FIELD CHANGE ORDER NUMBER: 9XXX-0012

APPLICABILITY: This "O" coded FCO should be installed on all VAX 9000-210, 410/420/430/440 systems shipped prior to Jun 91 in US/GIA and prior to Oct 91 in Europe. This FCO incorporates the following ECOs: 7027533-TW001, Rev D02 and 7027559-MR001, Rev D01.

PROBLEM & SYMPTOM: Capacitors are too difficult to assemble to buss bars. Capacitors are failing in the field due to severe overheating during mfg. process.

SOLUTION: A printed circuit board (54-21037-01) has been added to the assembly which requires much less heat needed to assemble capacitors.

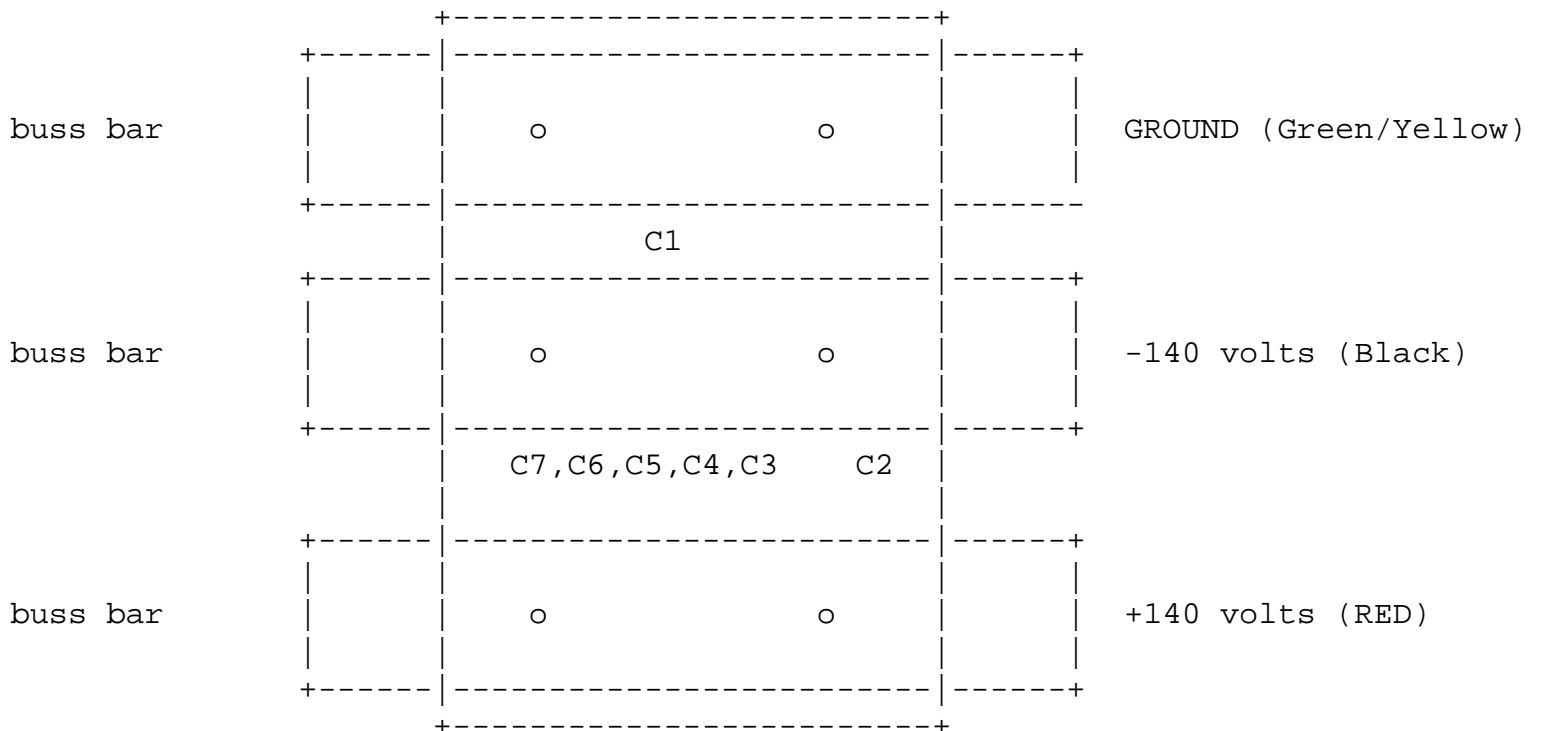
Then, using a 9/16 inch deep socket wrench, (29-28499-01), disconnect the three DC input wires, noting color code and physical wire connection to the buss bars.
